Hi-Fi Products Service Bulletin

Model: STR-VX550

No. 3

Subject: Missing 1S1555 Diode

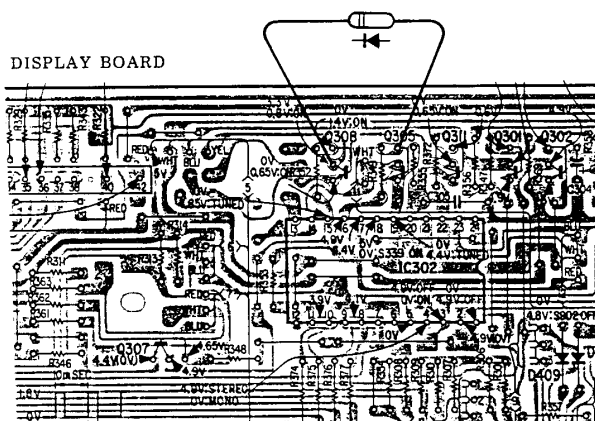
(151)
Early production of STR-VX550 diode 1S1555 was omitted from the display board.

Solution:
When servicing STR-VX550, check if this diode is installed. If the diode is missing, solder a 1S1555 between collector of Q308 and base of Q305. The cathode should be connected to the collector of Q308.

Add Diode 1S1555
Part No. 8-719-815-55
